Santa Catalina Towers Restroom & Deck Renovation
Project No. FM090053S/987711

Addendum No. 2

ADDENDUM NUMBER 2
to the
CONSTRUCTION DOCUMENTS

ABBREVIATIONS, SYMBOLS, SCHEDULES, & MECHANICAL DEMO PLAN

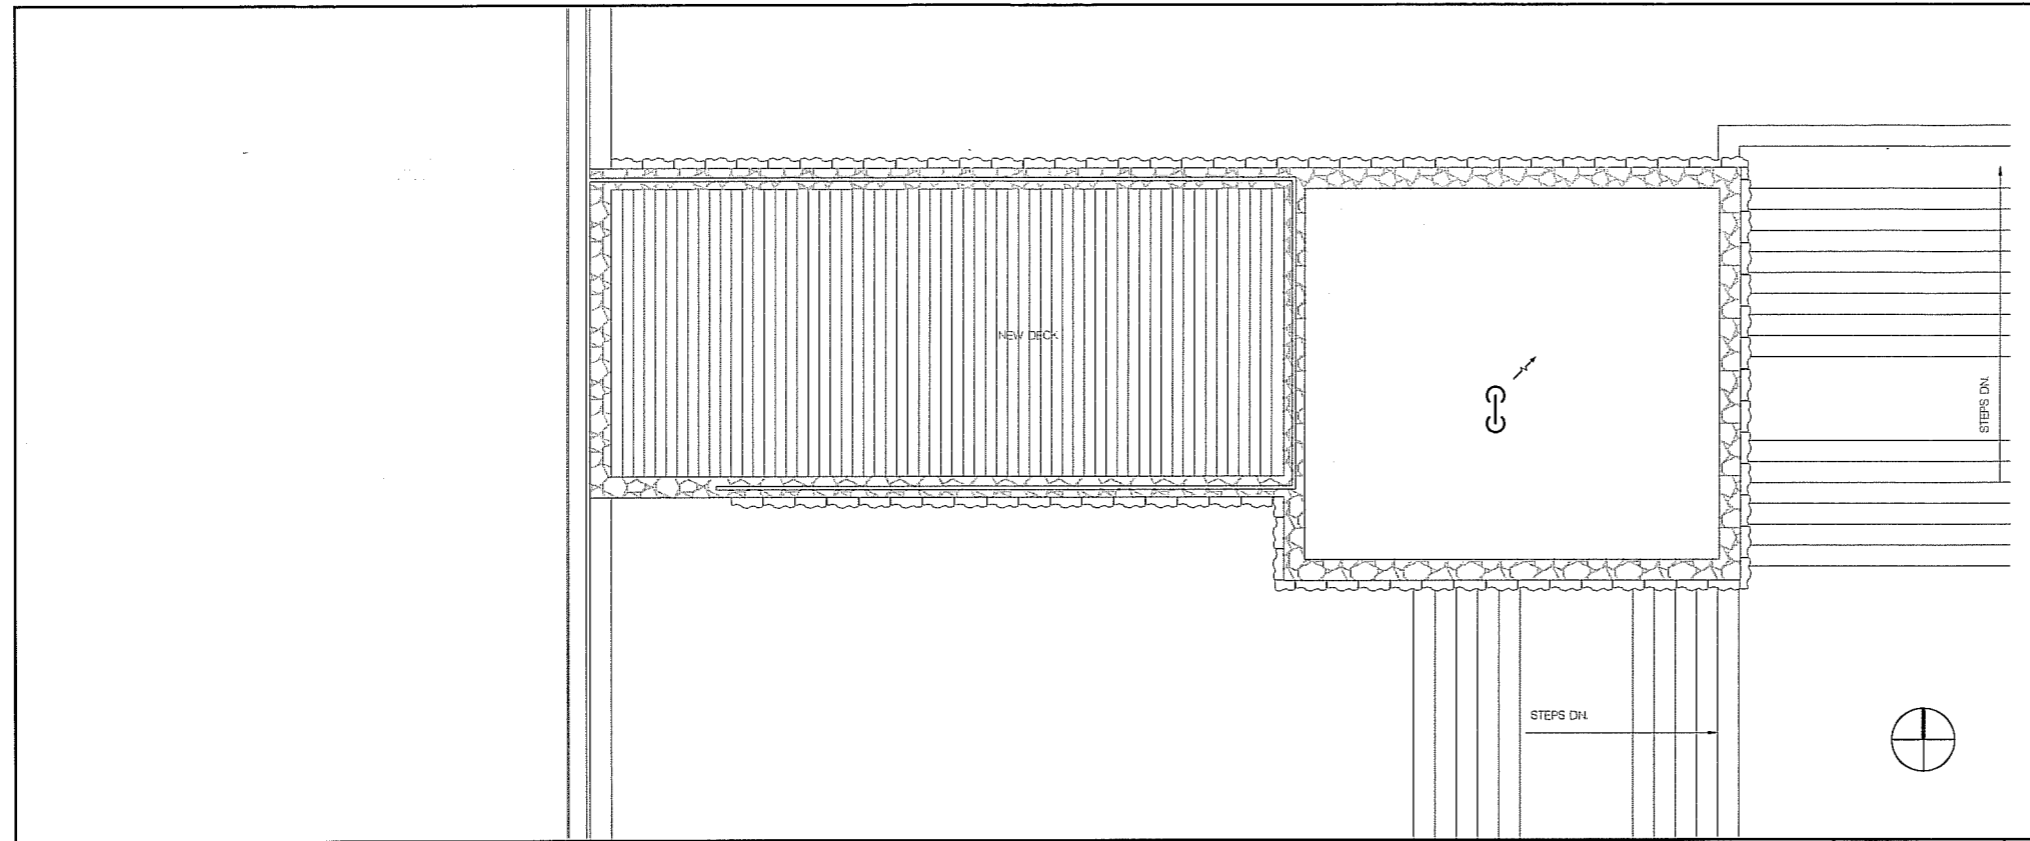
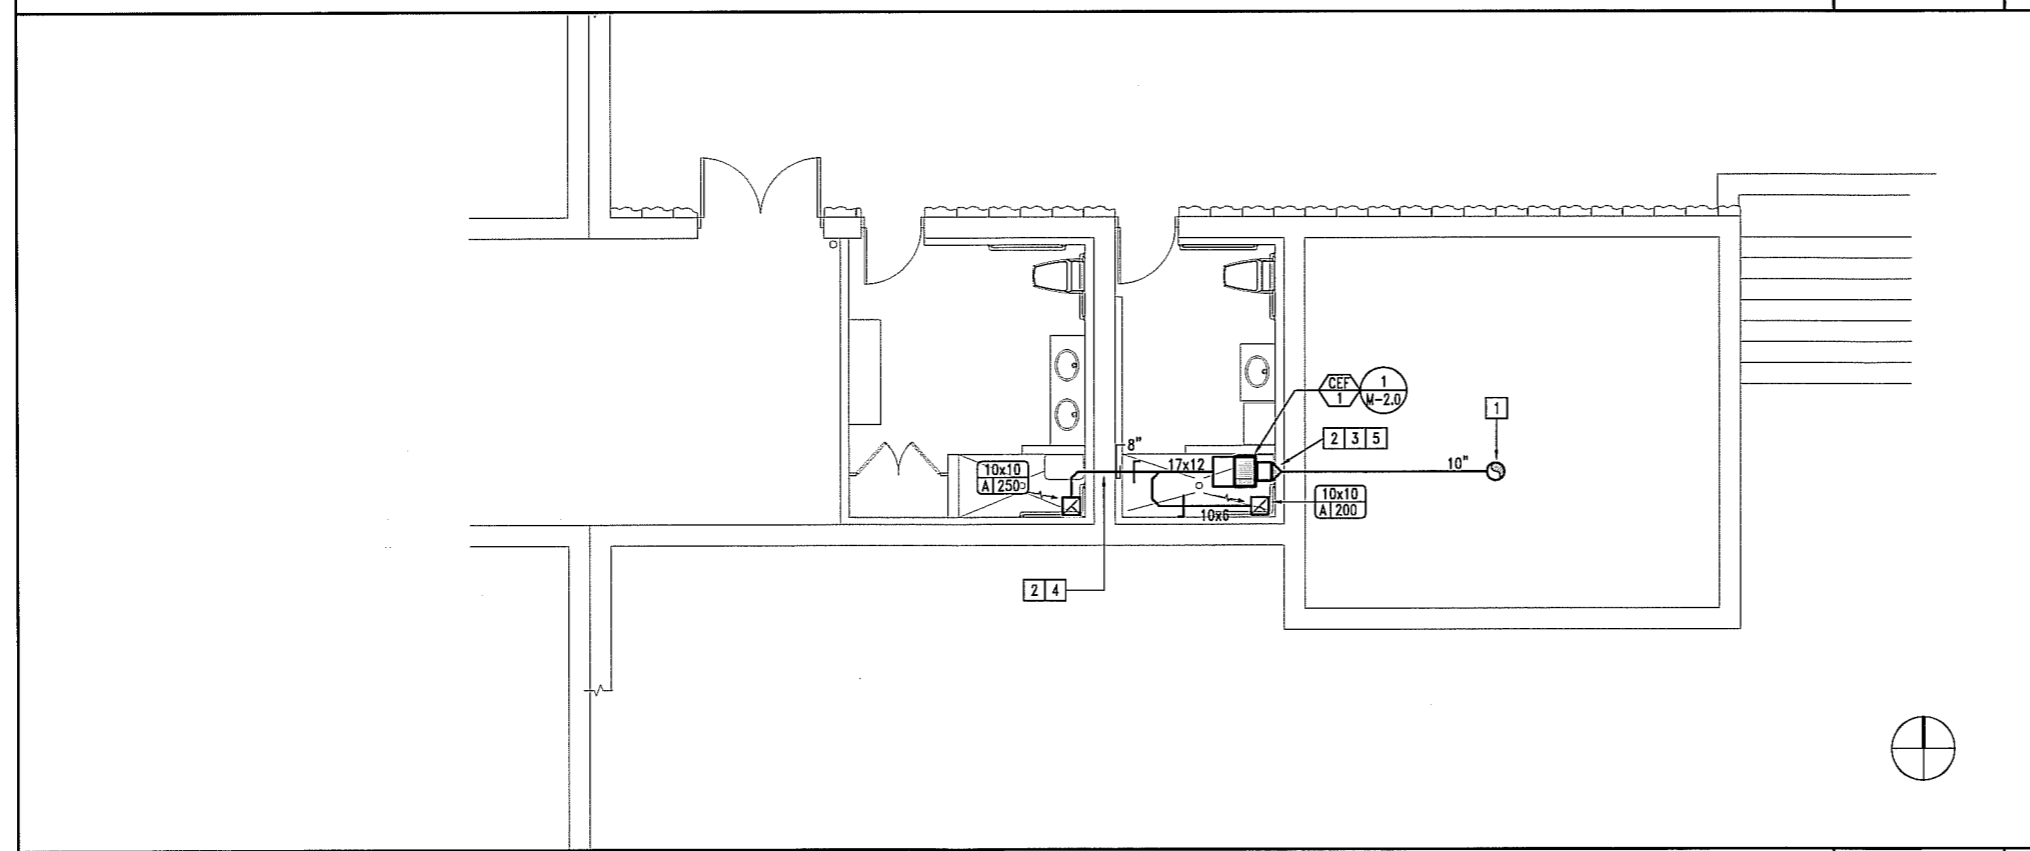
14. Sheet M-1 “Abbreviations, Symbols, Schedules, & Mechanical Demo Plan”:
Replace in its entirety with attached M-1 Abbreviations, Symbols, Schedules, & Mechanical Demo Plan.
